**SERVICE BULLETIN**

#0014 Revision 1

**SUBJECT:** Rivet replacement along fuselage main spar carry-through and on upper and lower inboard wing skins

**MODELS AFFECTED:** All Sling aircraft

Figure 1 - Paint cracking around rivets on Sling 2 wing

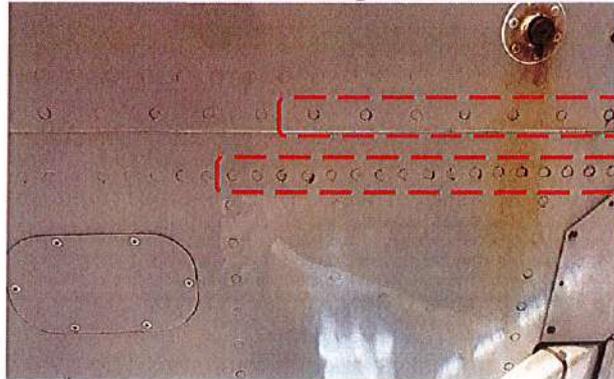
In some Sling aircraft, an indication of this condition is paint cracking around the rivets. The affected regions are usually located on the underside of the fuselage along the main spar carry-through and on upper and lower inboard wing skins. Figure 1 shows paint cracking on the inboard skins of a Sling 2 aircraft.

To minimise fretting, rivets in the affected areas should be replaced with Avinox stainless steel rivets (Part number BE61-00512).

Figure 2 – Region of rivet replacement on the underside of starboard (right) wing

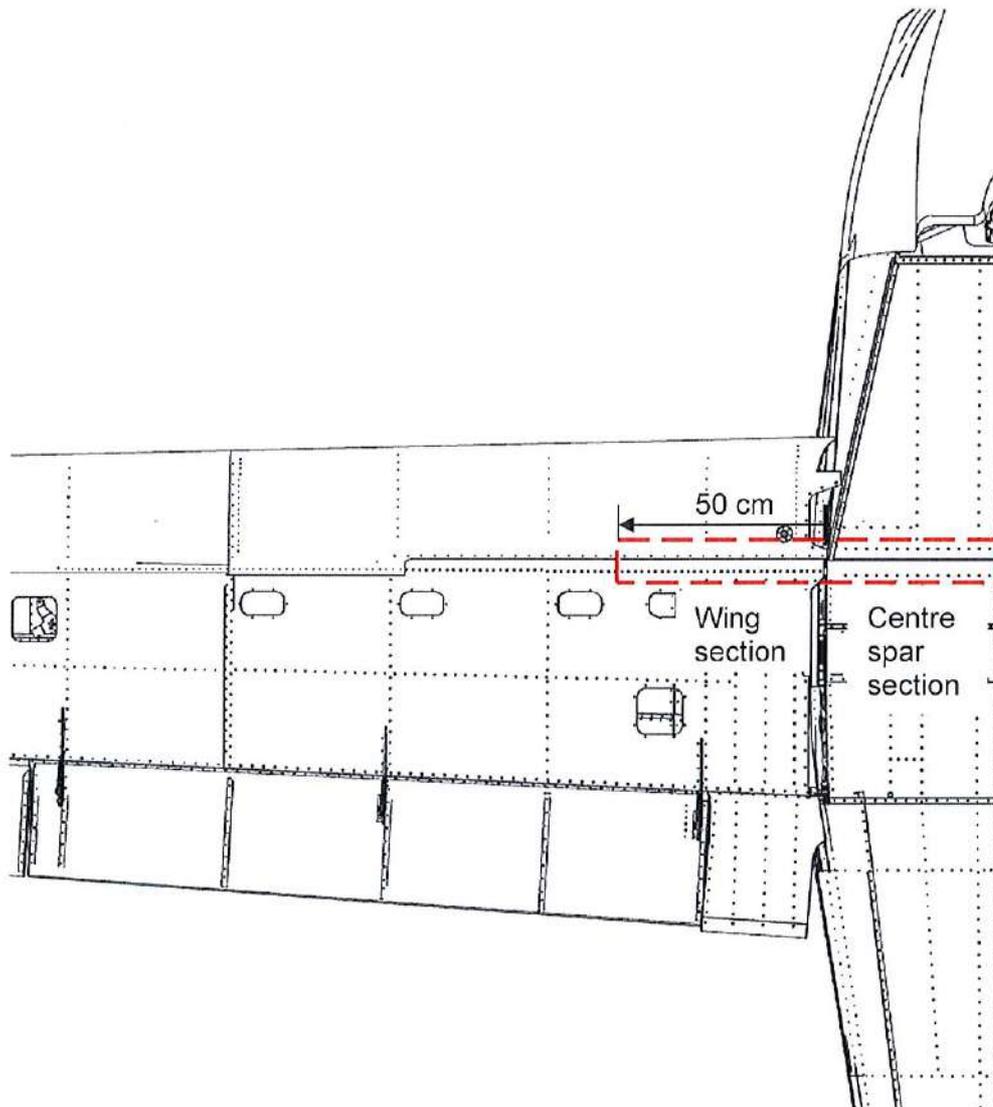
2. On the fuselage (of Sling TSi, Sling 2 and Sling 4 aircraft), this region is along the two rows of rivets that attach the underside centre fuselage skin to the centre spar (see Figure 2).

3. Figure 2 shows one half of the affected region on the underside of the starboard wing and fuselage and Figure 3 shows half the affected region on the upper starboard wing. The quantity of rivets recommended should cover these regions sufficiently.

The Figure 2 and 3 indicate the regions where rivets should be replaced on the aircraft. The rivets for the Sling TSi are replaced only on the centre spar carry-through under the fuselage.

5. Ensure that rivet removal is complete on the top of the wing before starting with the underside.
6. Using the powered drill with the 4 mm drill bit, drill the heads off rivets in the affected regions indicated in Figure 2 and 3 (specifically Figure 4 for Sling 2 and Figure 5 for Sling 4 wings). If rivets are filled, indent the centre of the rivet head with a centre punch and hammer before drilling.

Figure 4 - Number of rivets to replace on Sling 2 and Sling LSA wings

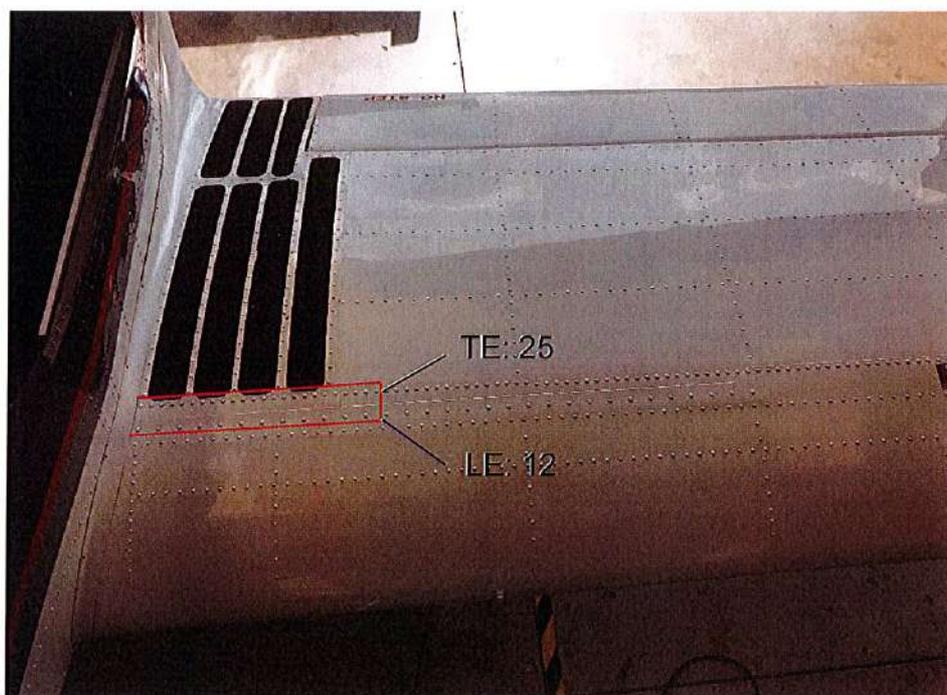
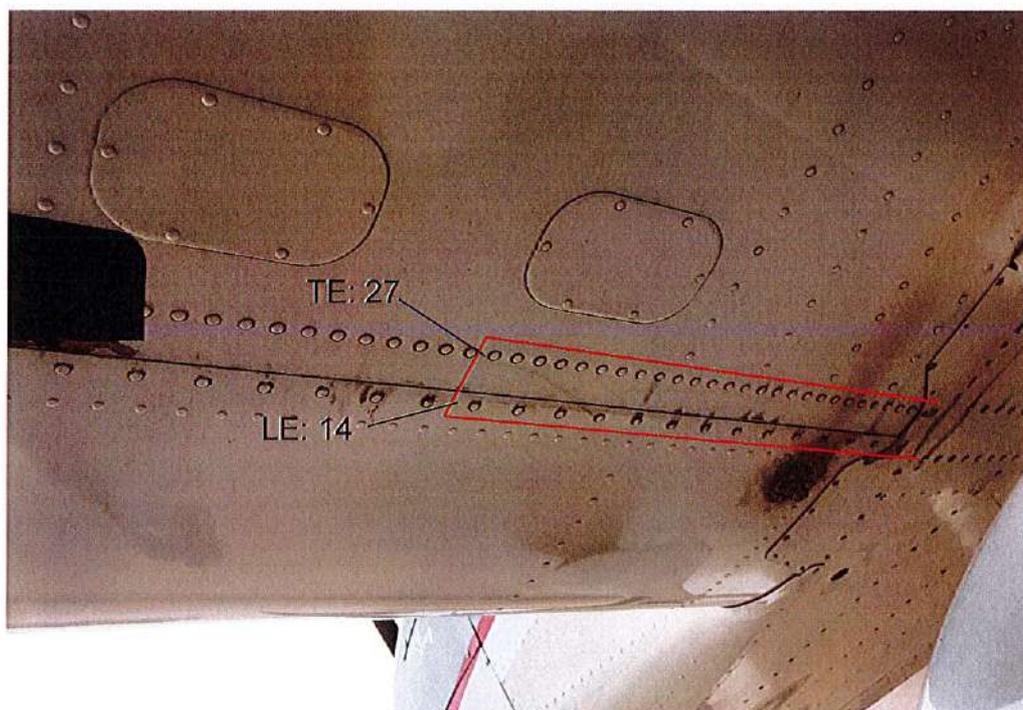
At approximately 50cm (spanwise distance) from the wing root, on the Sling 2 wings, the rivets to be replaced are 12 on the front section (leading edge) and 25 on rear section (trailing edge) of the upper wing spar. On the underside of the Sling 2 wing, the rivets to be replaced are 14 on the leading edge and 27 on the trailing edge as shown in Figure 4.

Hence, the total number of rivets, for both wings =  $[(12 + 25) + (14 + 27)] \times 2 \rightarrow 156$  (wings only).

In total:  $(156 + 62) \rightarrow 218$  rivets (Sling 2)

Figure 5 - Number of rivets to replace on Sling 4 wings

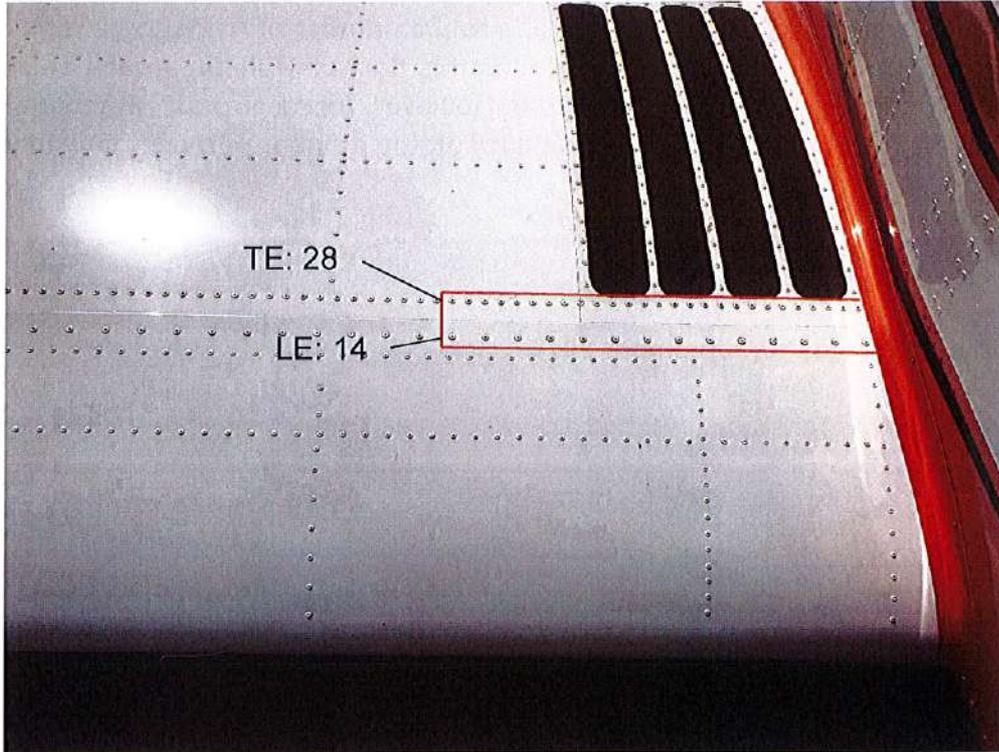
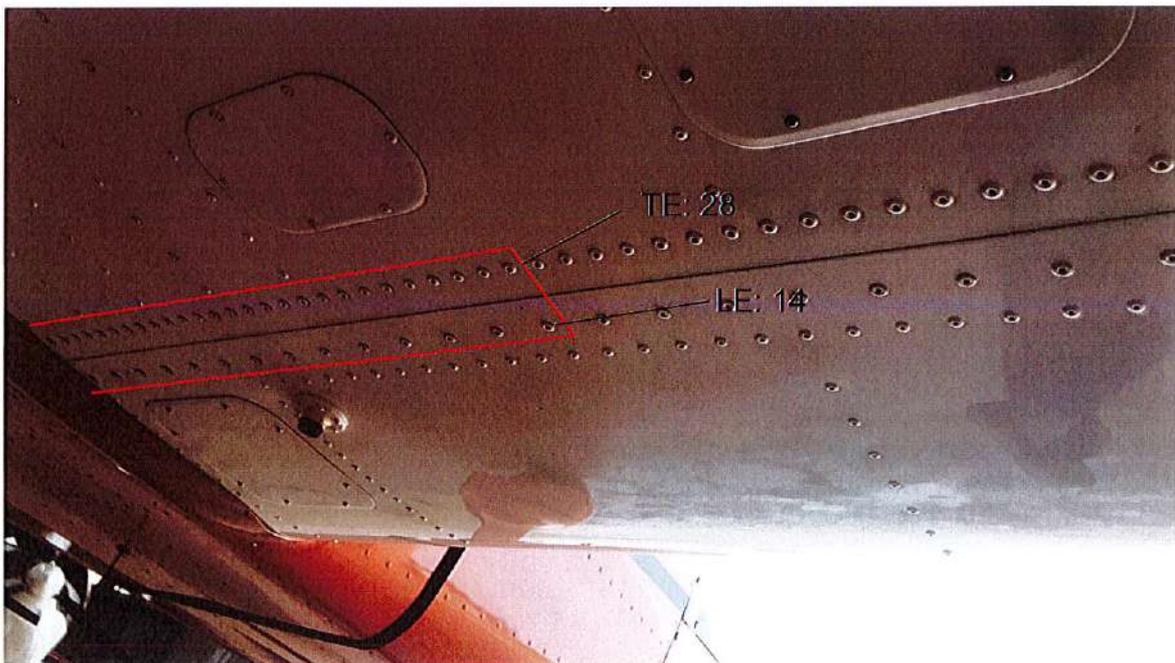
As illustrated below, on the Sling 4 wings, the rivets to be replaced are 14 on the front section (leading edge) and 28 on rear section (trailing edge) of the upper wing spar. On the underside of the Sling 4 wing, the rivets to be replaced are again 14 on the leading edge and 28 on the trailing edge. Hence, the total number of rivets, for both wings =  $[(14 + 28) + (14 + 28)] \times 2 \rightarrow 168$  (wings only). The number of rivets along the centre spar carry-through under the fuselage  $\rightarrow 62$  (centre spar only). In total:  $(168 + 62) \rightarrow 230$  rivets (Sling 4)
